June 8, 2012

Serial No. 12-352
LIC/CDS/R2
Docket No.: 50-305
License No.: DPR-43

KEWAUNEE POWER STATION

**RESPONSE TO REQUEST FOR ADDITIONAL INFORMATION RELATED TO THE
ESTIMATED EFFECT ON PEAK CLADDING TEMPERATURE RESULTING FROM
THERMAL CONDUCTIVITY DEGRADATION IN THE WESTINGHOUSE FURNISHED
REALISTIC EMERGENCY CORE COOLING SYSTEM (ECCS) EVALUATION
PURSUANT TO THE REQUIREMENTS OF 10 CFR 50.46**

**Figure 3-1: Kewaunee Cycles 30, 31 and 32
 $F\Delta H$ vs Rod Burnup**

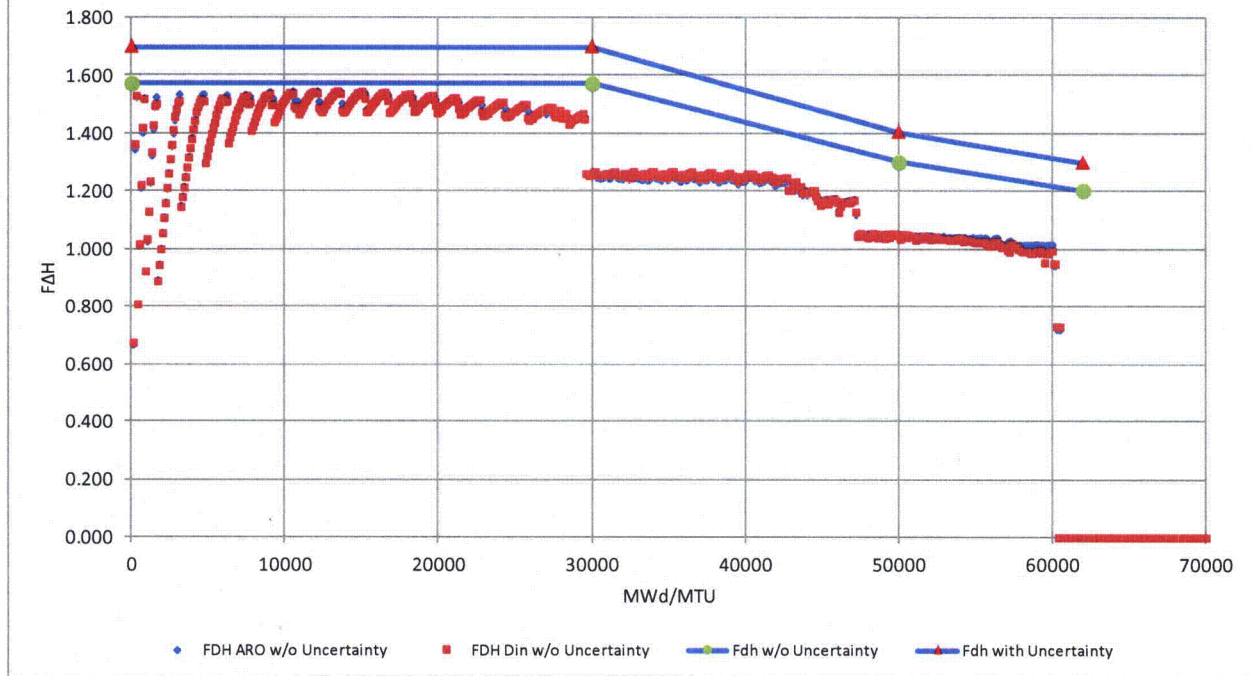
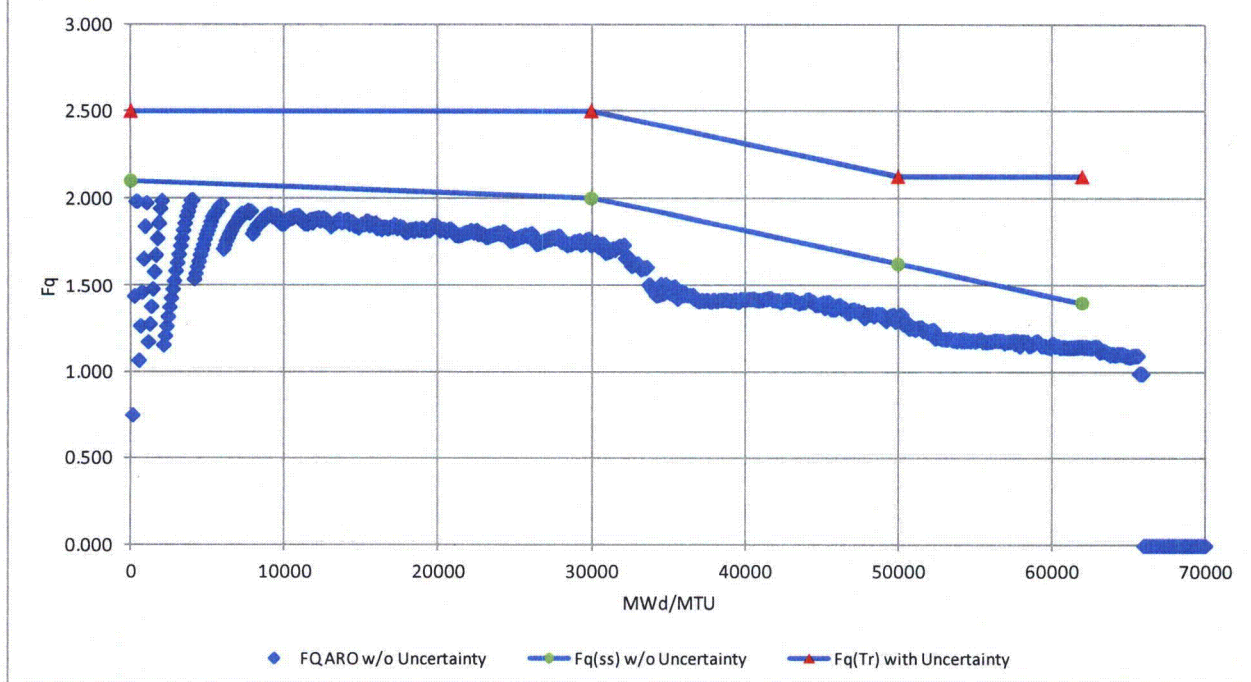
Fully explain all peaking factor adjustments and provide the rationale for each adjustment.

Figure 3-1 compares $F\Delta H$ peaking factor limits (with and without uncertainty) to the cycle design data without uncertainty. The $F\Delta H$ was obtained with all-rods-out (ARO) and with D-Bank at the rod insertion limits (RILs). Figure 3-2 compares the FQ Steady-State peaking factor limit to the cycle design data without uncertainty at ARO conditions. Figure 3-2 also shows the FQ Transient limit. The FQ Transient limit is reduced by an amount less than or equal to the reduction in the FQ Steady-State limit. The relationship between transient and steady-state FQ was evaluated for Cycle 32. FQ Transient decreases with local burnup by a larger amount than the decrease in FQ Steady-State at higher fuel burnups. The FQ Transient and the FQ Steady-State values are bounded by their respective limit curves. Thus, the FQ Steady-State limit and the FQ Transient limit are verified.

Figure 3-1 and Figure 3-2 show that the peaking factor limits used in the LBLOCA TCD analysis are conservative with respect to cycle design data. In addition, Dominion confirmed that the hot assembly average power burndown assumption in the LBLOCA TCD evaluation was bounding. As stated in DEK's letter dated March 15, 2012 (Reference 2), the peaking factor burndown limits in Table 3-1 were incorporated into the reload core design process (via the Reload Safety Analysis Checklist) and will continue to be verified for future KPS core designs to ensure that the LBLOCA TCD PCT estimate remains conservative.
